ADDENDUM NO. 2

Project: Miracle of Hickory Park - Modification
City of Hickory, North Carolina

Date: September 21, 2026

Miracle of Hickory Park – RFIs

A1.1

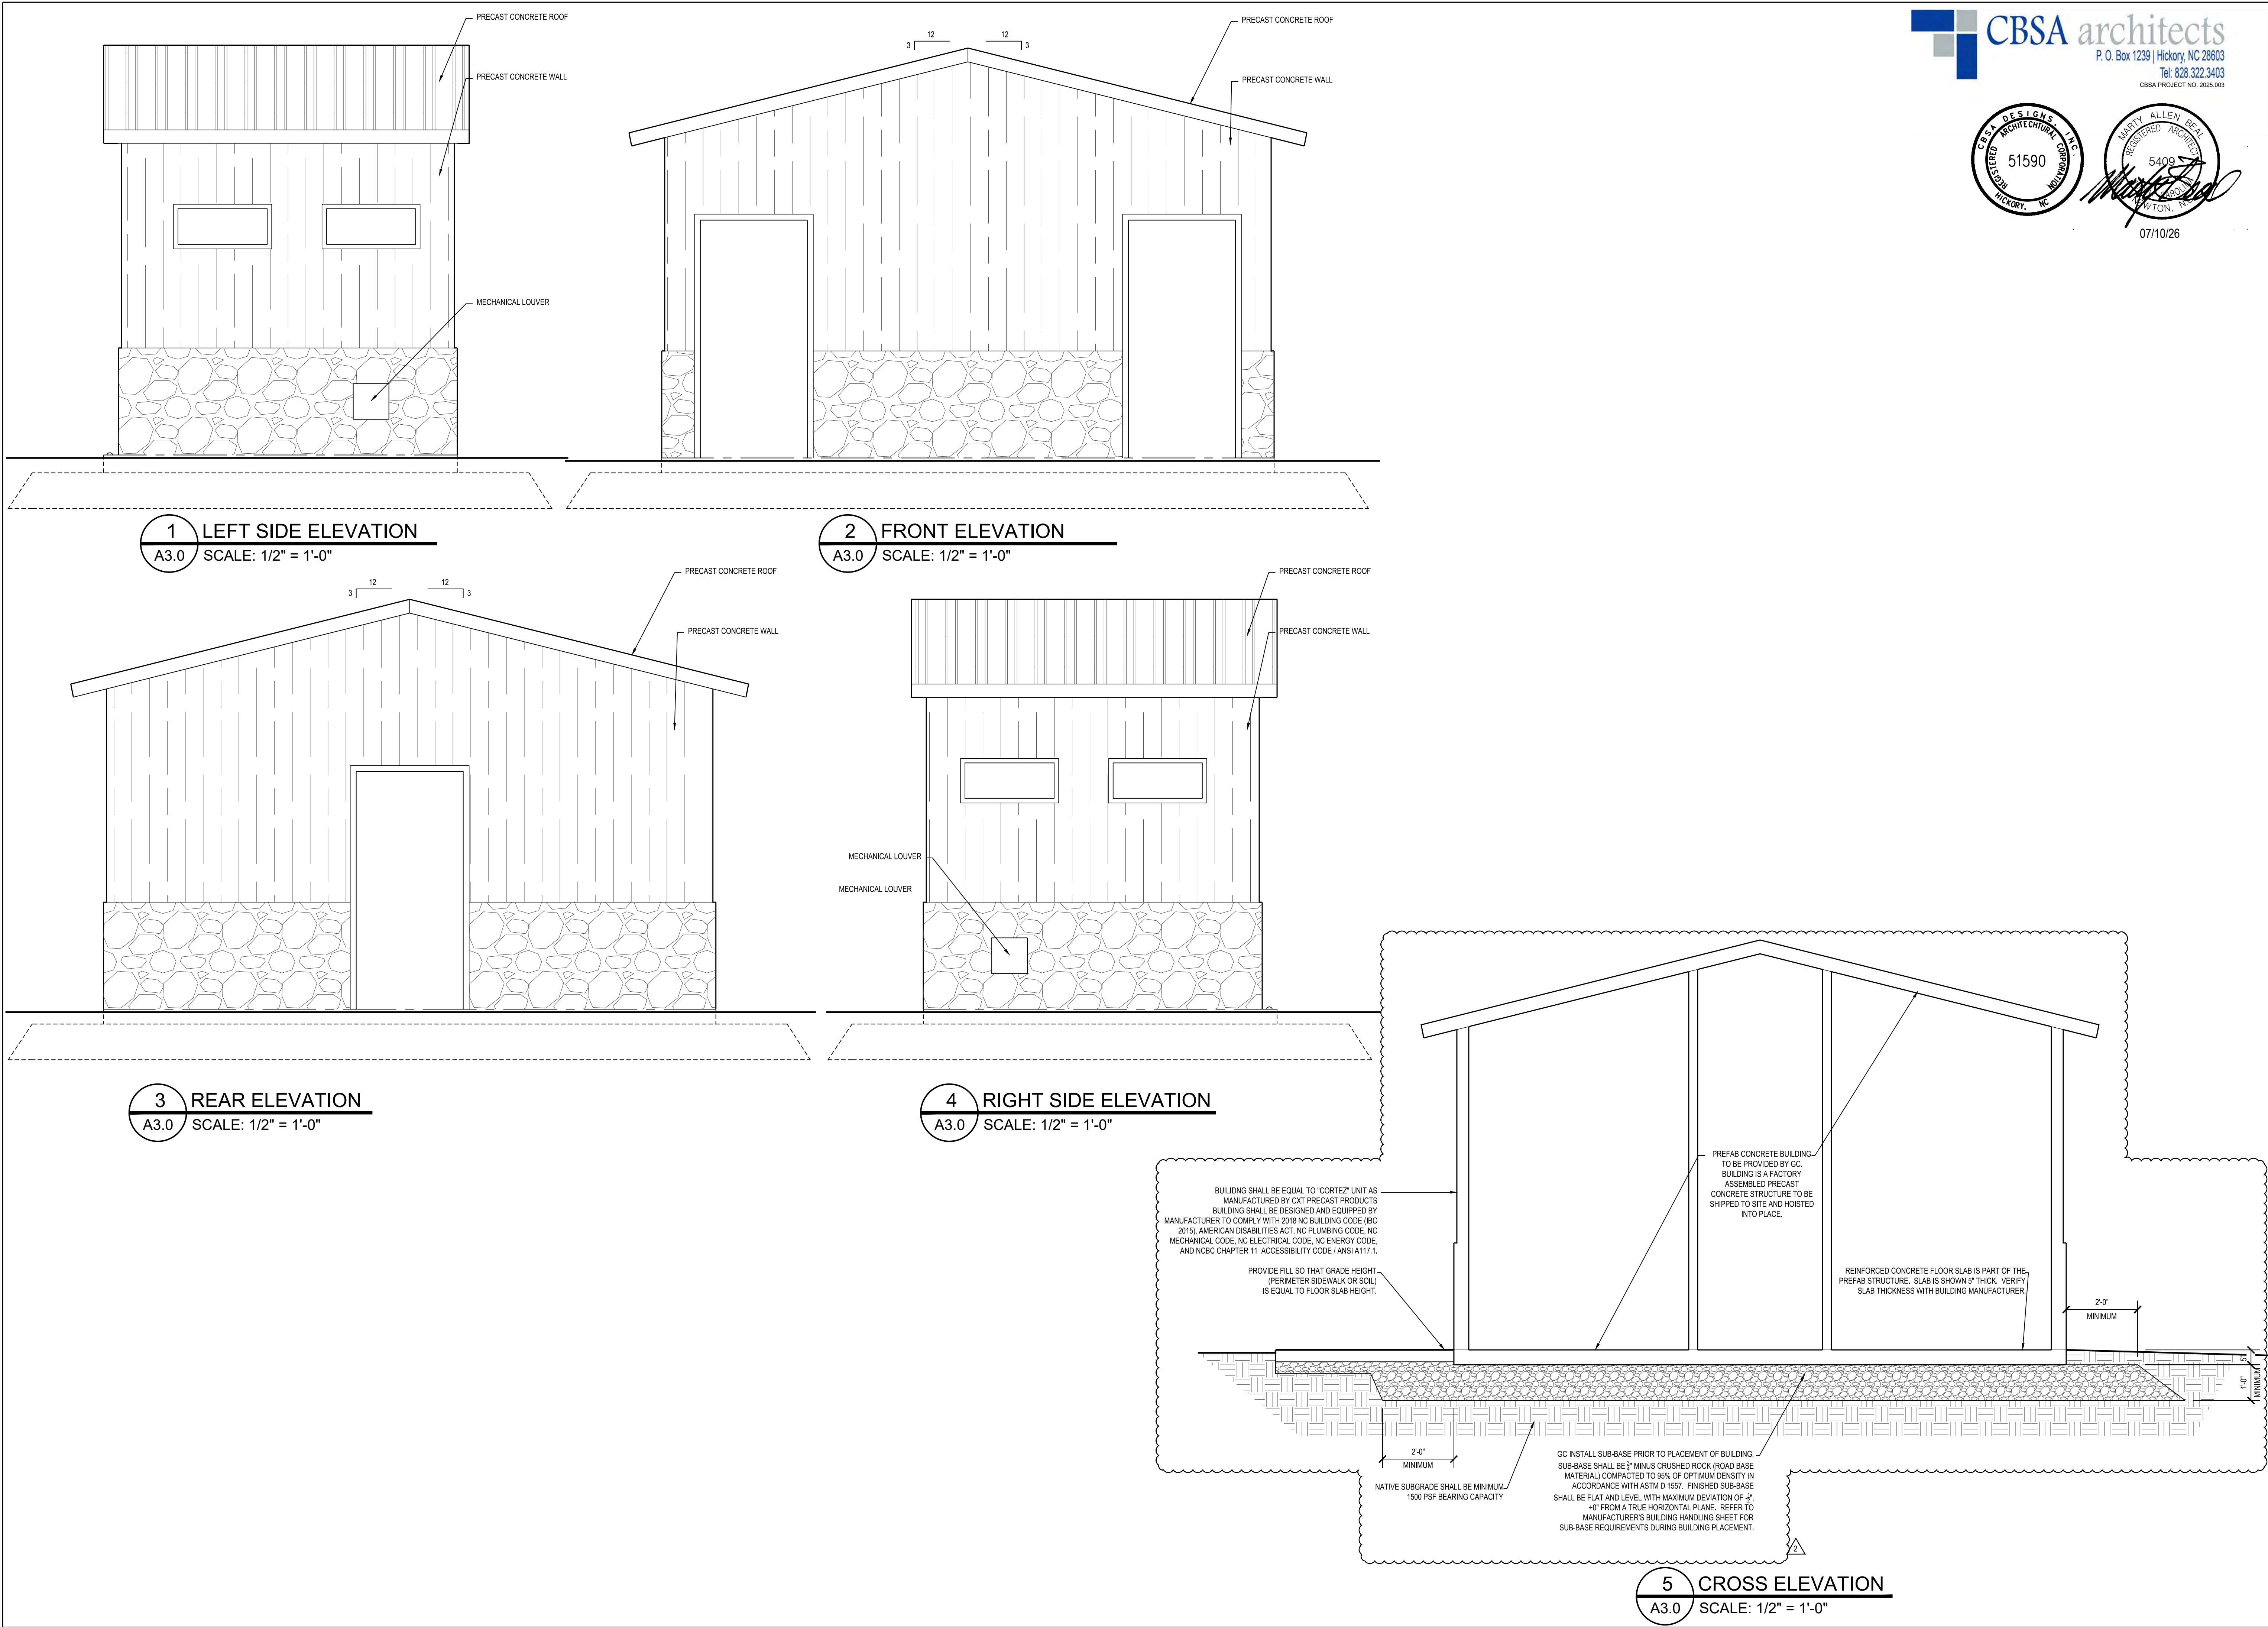
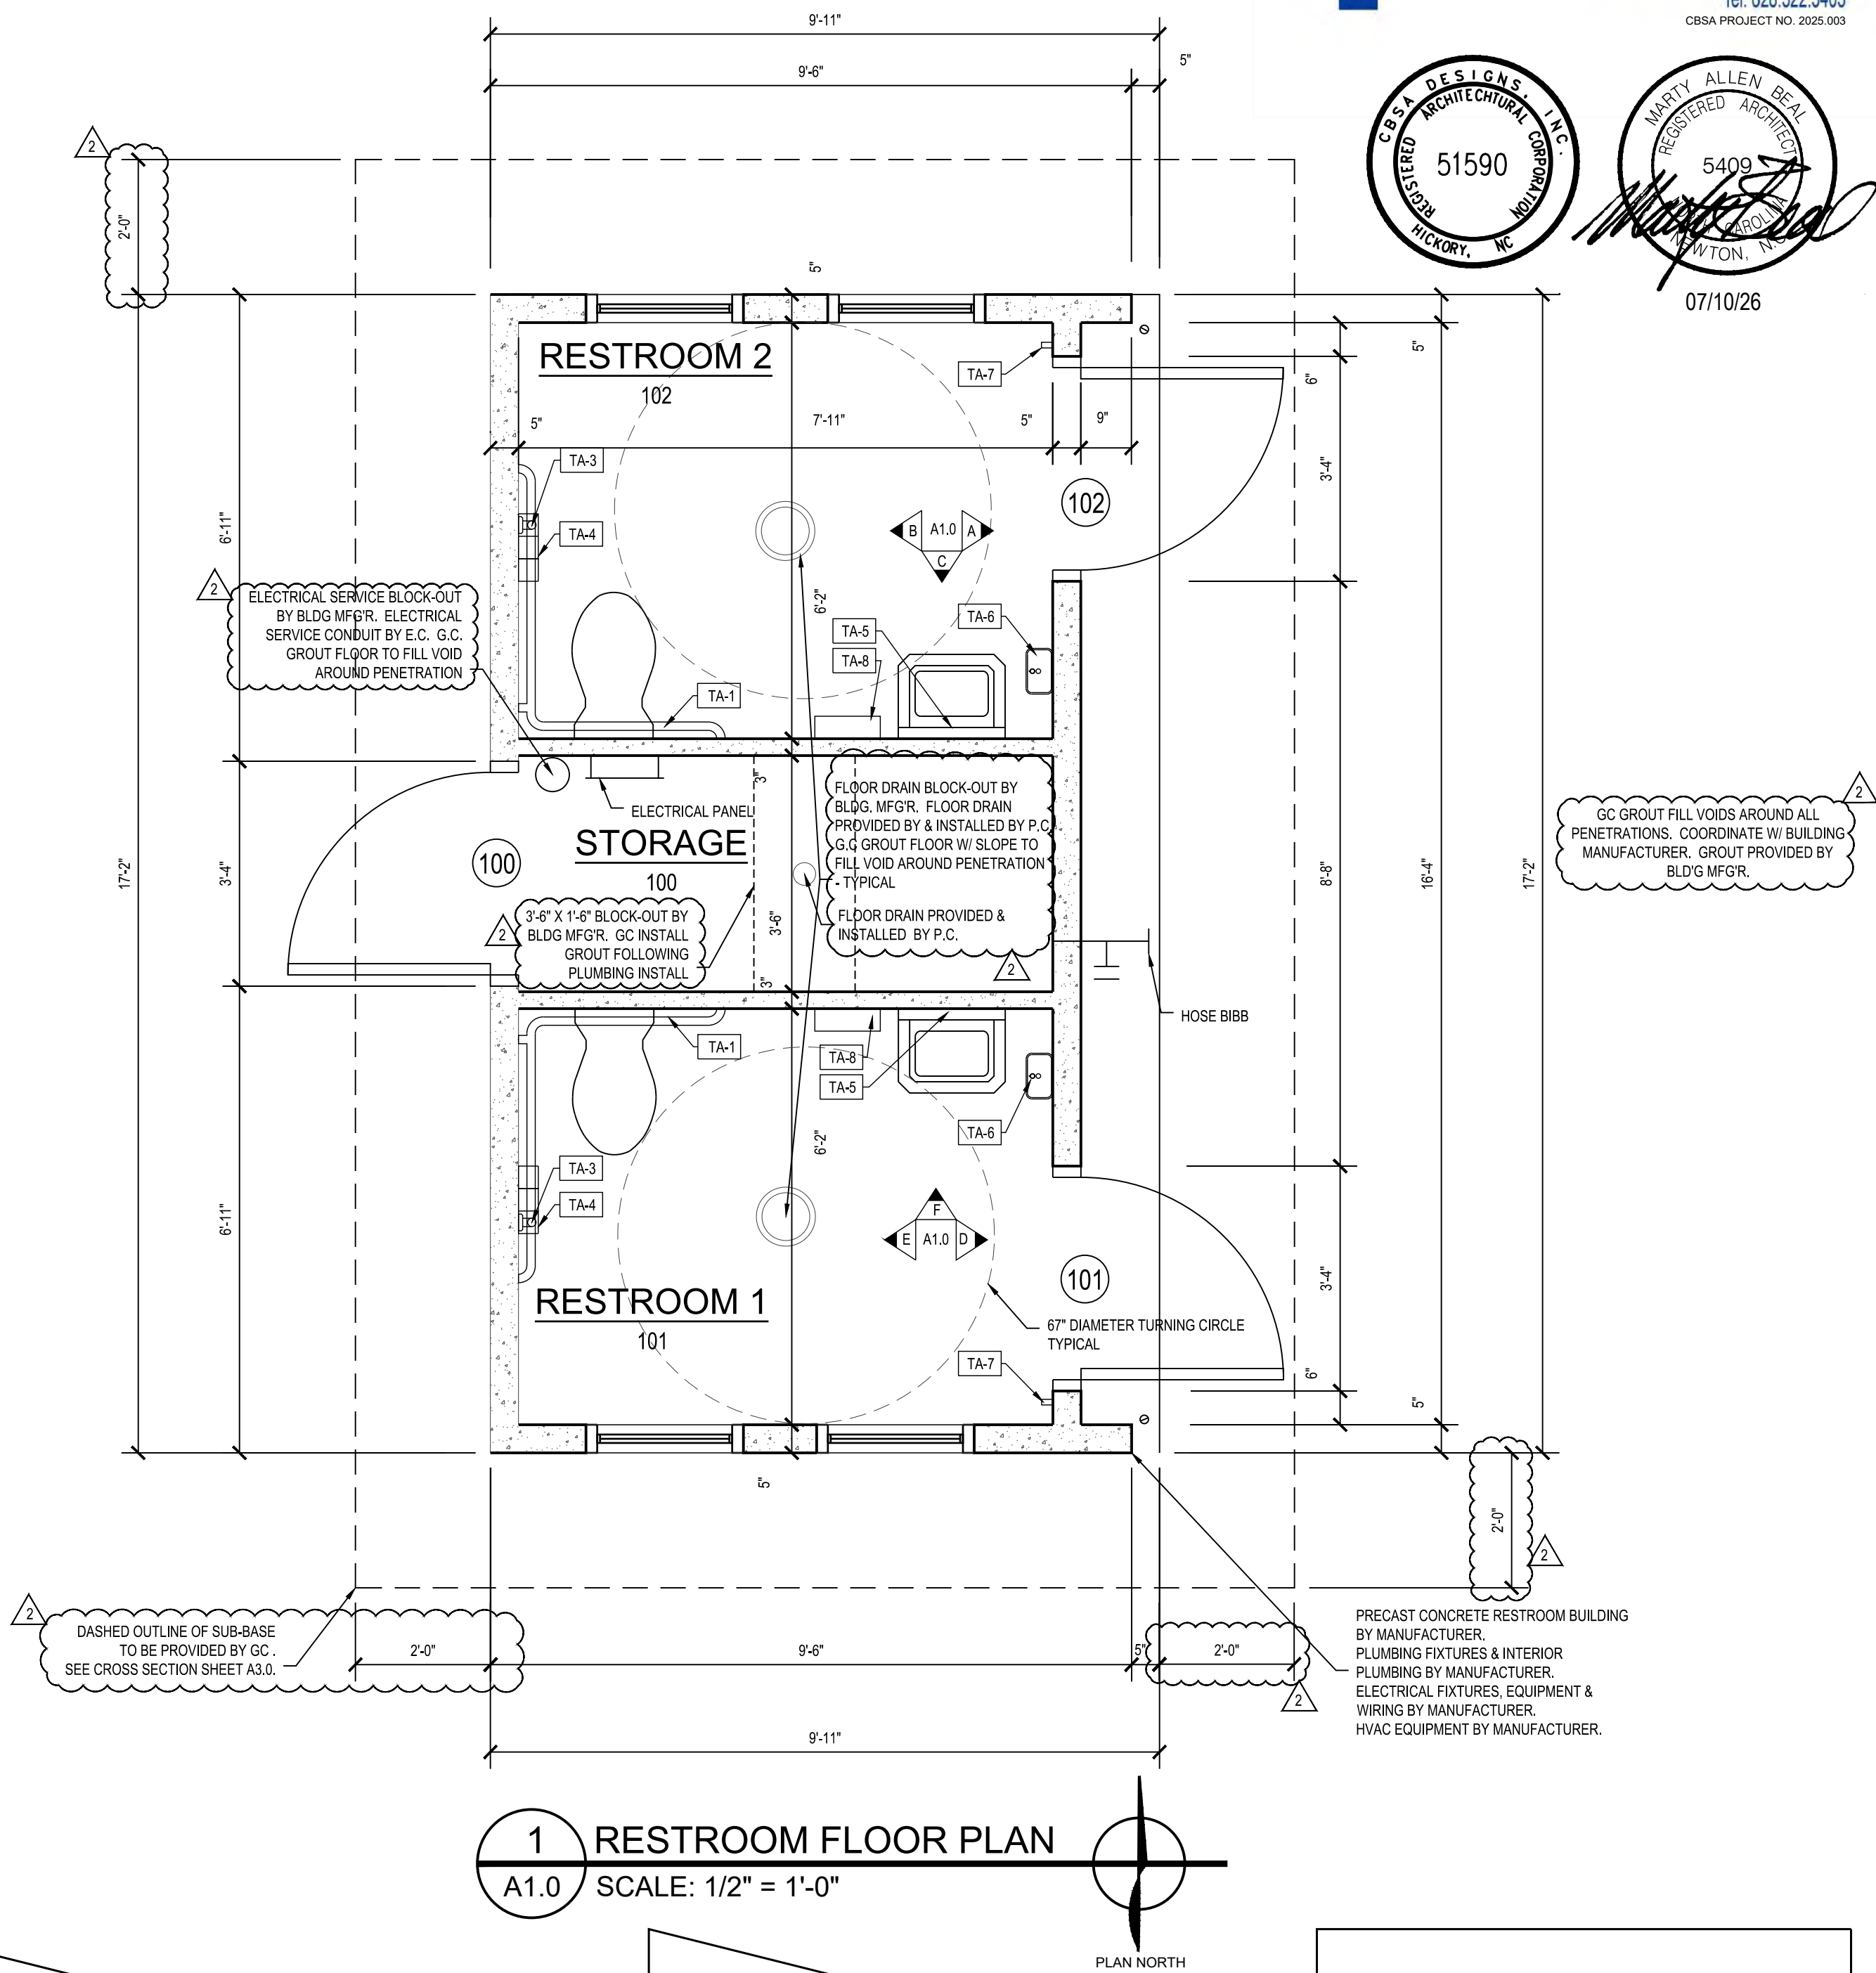
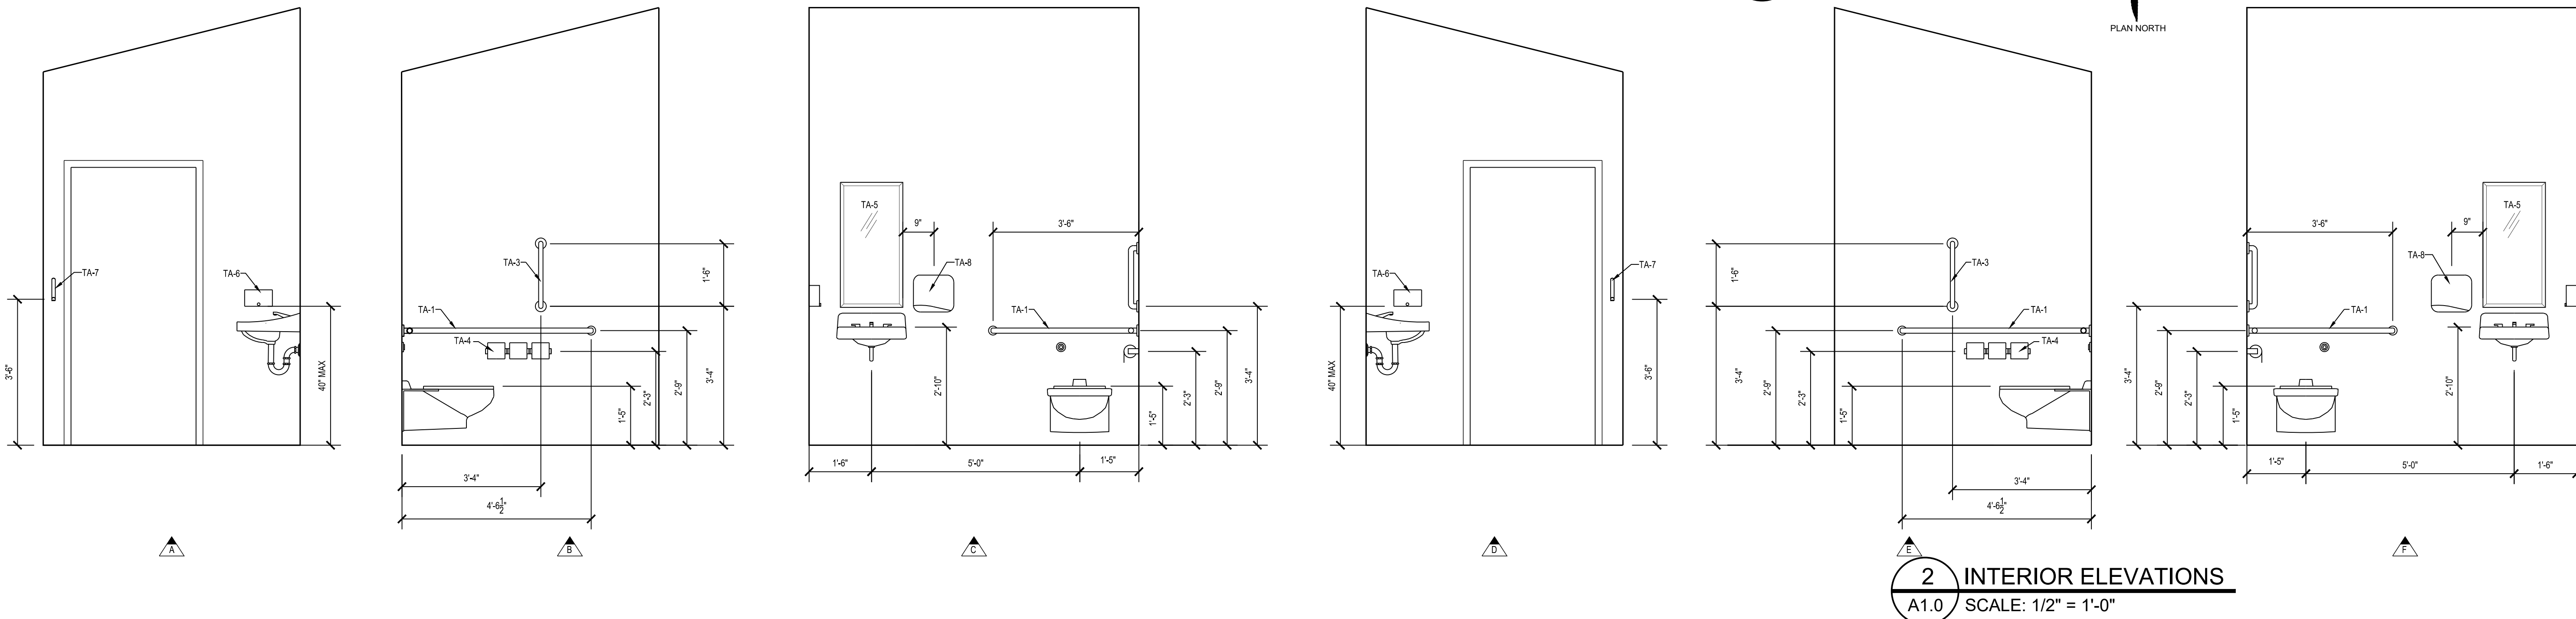
6. There are no foundation details provided for the CXT building. It is understood that the CXT building is furnished as a complete building package; however, the bidding GCs need sufficient information to accurately account for the required foundation, including any excavation, stone, concrete, reinforcing, or other related work. Without the applicable foundation requirements, GCs may make different assumptions regarding this scope, which could result in inconsistent or incomplete bids. Please provide the applicable CXT drawings and foundation details that correspond with the basis of design so all bidders can accurately price this scope. *R. All relevant CXT drawings can be found on their webpage under "Resources and Specifications" (<https://lbfooster.com/infrastructure/precast-concrete-buildings/restroom-buildings/cortez>). A 12" stone subgrade extending 2'-0" beyond the building slab edge has been reflected on the revised architectural sheets.*

D WATER PRESSURE REDUCING VALVE AND BACKFLOW PREVENTER STATION BY P.C.

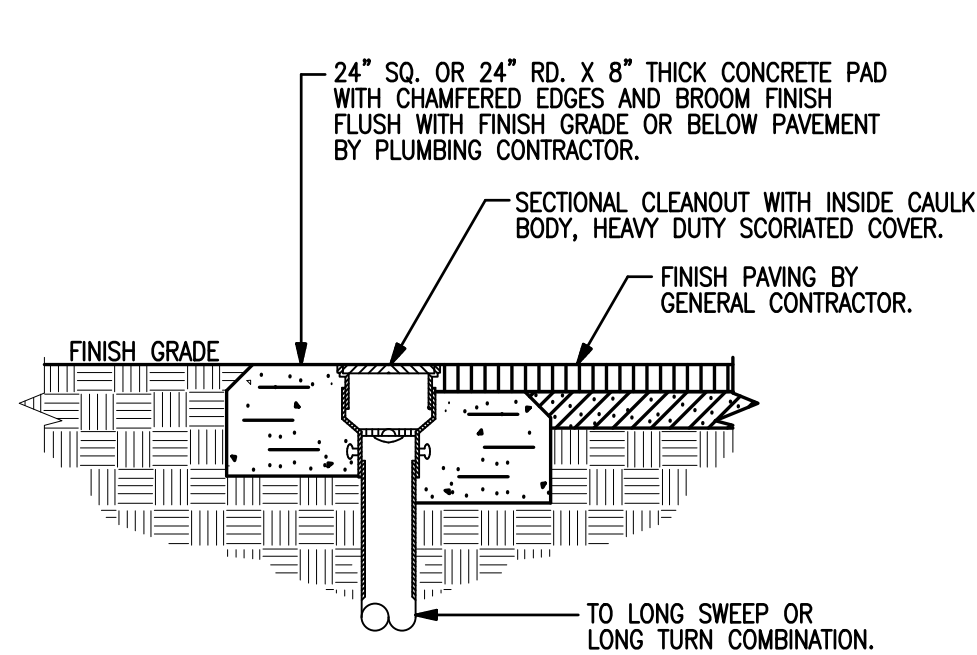
2. Will we be required to install a backflow preventer in the building? If so, please specify explicitly on the plumbing sheets. CXT buildings no longer come with backflow preventers like they have in the past. *R. A backflow preventor has been added to the storage room. See revised plumbing sheet.*
